Introduction

GSI-191 Program Overview

Selected Insulation Destruction Pressures

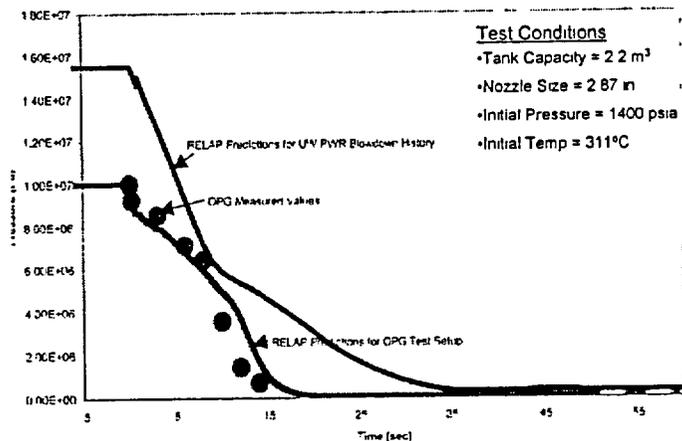
5 DR. RANSOM: Well, the L/D limits that
6 you're using in this representation I assume are
7 derived from data that you've taken where you've shot,
8 broke a pipe and had it shoot at directly some
9 insulated component, I guess, right?

13 DR. KRESS: Before you go to the next
14 figure, I'm intrigued by your description of the
15 guillotine break separating, which would form two
16 cones. It seems to me like the conservative
17 assumption would be, if that happens, you take twice
18 this volume, because each cone is going to take out
19 its fraction of the debris.

20 DR. BANERJEE: At half the pressure
21 though. There's only half the flow. I mean he's
22 looking at impact pressure.

1 The next slide, page 18, shows some more
2 quantitative information, so that you have an
3 impression of what the various vulnerabilities are.
4 Higher damage pressures imply a more robust insulation
5 application.

6 DR. FORD: And this is based on just
7 firing a jet at some things in the laboratory?

8 DR. LETELLIER: That's correct.
9 Unprotected fiberglass is perhaps some of the most
10 vulnerable material, having damage pressures in the
11 range of 6 to 10 psi.

12 DR. KRESS: Is old insulation worse than
13 new insulation?

18 DR. BANERJEE: So Min-K is fiberglass?
19 What is Min-K?

23 CHAIRMAN WALLIS: -- planktonic things,
24 but if they're not bonded together, it's not going to
25 have this 160 psi resistance.

7 MR. ROSEN: On that previous figure, is
8 there any thermal lag in these containments?

10 DR. LETELLIER: That is correct. And on
11 the next figure is a more quantitative representation
12 of this information.

1 DR. LETELLIER: The correlations do
2 account for that effect because they are a function of
3 both separation and displacement, and I'm not
4 personally familiar --

7 DR. LETELLIER: Yes, there is.

12 DR. LETELLIER: The length is the radius
13 away from the break --

15 DR. LETELLIER: -- compared to the pipe
16 diameter.

19 DR. LETELLIER: Yes, assuming a guillotine
20 break.

24 DR. LETELLIER: No, it's correlated to the
25 diameter, actually the physical diameter of the pipe.

14 DR. LETELLIER: I can't comment on that.
15 There are aging effects that affect the friability of
16 this material. We have to look at other documents to
17 answer that.

1 DR. LETELIER: No. In fact, the robust
2 nature of the Calcium-Silicate with the aluminum
3 jacket was actually viewed to be a limitation of the
4 existing BWR data. That's one of the reasons that we
5 requested a test program, in cooperation with Ontario
6 Power Generation, on the next figure.

Example Section of Debris Transport Chart

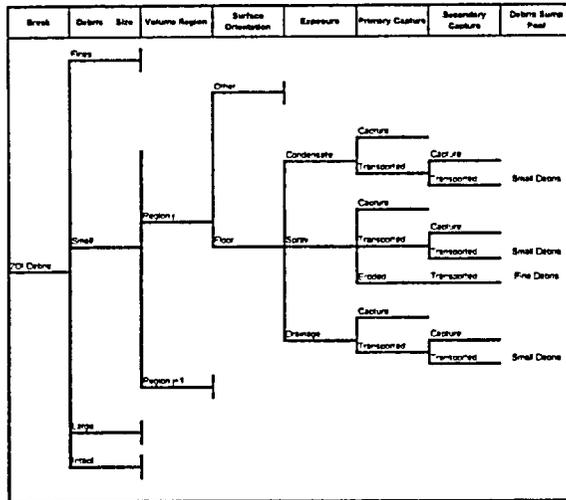
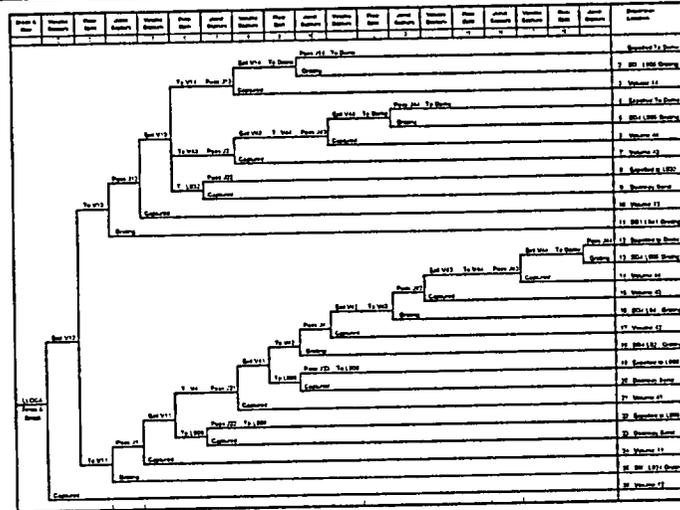
21 This is on Figure 27, which is a schematic
22 of the logic chart, but in the next two pages, 28 and
23 29, you can see that you can get carried away with
24 this level of detail.

18 DR. BANERJEE: Do you think this level of
19 detail is appropriate? I mean, it's like having too
20 many significant figures in a number.

7 DR. BANERJEE: But do you need this level
8 of detail to do that?

9 DR. LETELLIER: The answer is no.

14 DR. LETELLIER: This is illustrative and
15 it's also educational, if you will. It lets the
16 plants prioritize where to put their analysis effort.

9 DR. LETELLIER: It basically walks you
10 through the disposition of a debris fragment depending
11 on its size, whether it's initially deposited on the
12 floor, on a vertical surface, on a horizontal surface;
13 whether it's impacted by sprays, direct impingement,
14 or condensation; whether it is subject to secondary
15 motion through pools on elevations, different
16 elevations of the plant, and, eventually, whether it's
17 deposited into the pool.

4 DR. LETELLIER: Yes. And what we've
5 learned by this exercise is that there's not a great
6 return to be gained by the plants investigating this
7 in detail.

Max Velocity 0.2 ft/s

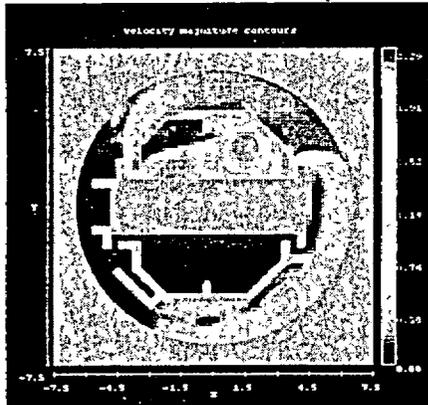
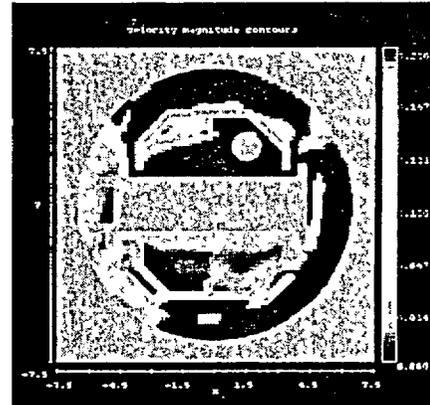
6 DR. BANERJEE: Is this a plan view?

7 DR. LETELLIER: It is. It is a plan view
8 at the floor level of a representative of --

5 DR. LETELLIER: The figure on the right
6 has been scaled to a maximum velocity of .2 feet per
7 second. From the individual effects test, that's sort
8 of a rule-of-thumb threshold for debris movement. If
9 it exceeds .2, it's very likely to be mobile. If it's
10 less than .2, there's an opportunity for settling.

Transport Required for Failure

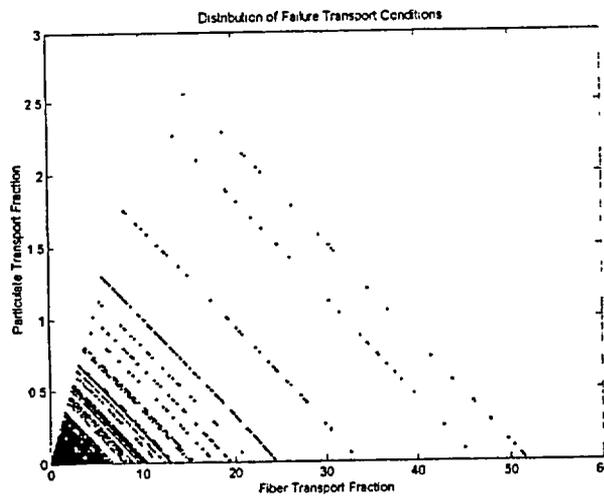
1 figure on 43 looks at the vulnerability of a specific
2 sump to a challenge of various combinations of fiber
3 and particulate. This is the threshold for failure
4 where they exceed their NPSH margin.

5 If you combine this failure threshold with
6 all of the debris sources, you can generate the last
7 figure, which shows you the range of pool -- well, of
8 total transport that would be required to induce
9 failure of the screen.

18 DR. LETELLIER: Again, these dots on this
19 Figure 44 do not represent particulates. They
20 represent scenarios.

18 CHAIRMAN WALLIS: This is for an existing
19 screen and a real reactor, a real containment, this
20 figure?

15 DR. LETELLIER: This is a representation
16 of a screen. Depending on the area and the approach
17 velocity, there are plant configurations that could be
18 blocked with one cubic foot of fiber and some amount
19 of particulate. That's not a generic statement.
20 That's very plant-specific.

22 DR. LETELLIER: Now your comment about the
23 threshold, at the far left there is a missing line
24 that essentially extends vertically upward.

23 DR. LETELLIER: It is illustrative of
24 plant conditions with very high approach velocities
25 and very small screen areas.

12 DR. LETELLIER: That is correct, but the
13 point of this slide is to demonstrate that the
14 licensees need to assess their own vulnerabilities in
15 much the same way. They need to have an understanding
16 of transport and head loss in order to respond to the
17 Generic Letter.
